FMB140 Product Change Notifications

Product change notifications (PCN) is the way of informing customers of upcoming changes related to Teltonika products. This includes outward appearance adjustments, hardware improvements, firmware changes, changes to package contents, etc. This page stores information regarding changes to the FMB140 tracking device. Below you will find a list of both upcoming and already implemented changes sorted from newest to oldest (top to bottom).

2021.04.16: Top Laser Printing Changes

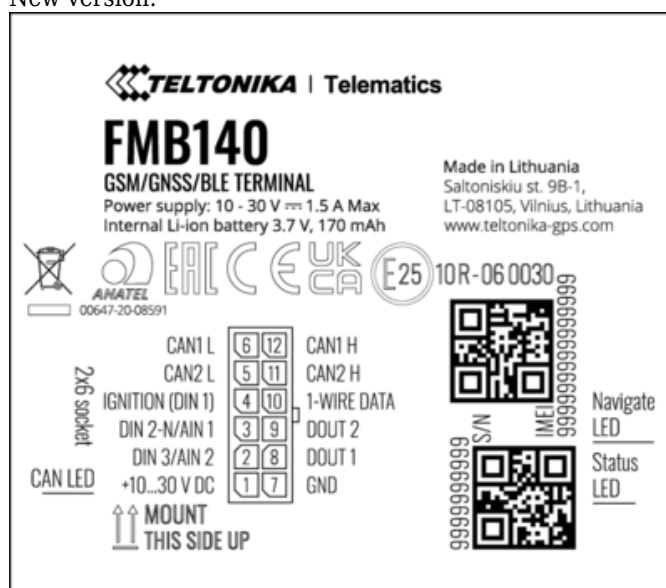
We would like to inform you, that laser printing of the FMB140 device was updated in the factory on April 2021.

Change type	External/visual
	Top laser printing design changed

Change reasons 1. Added ANATEL label and certificate number.
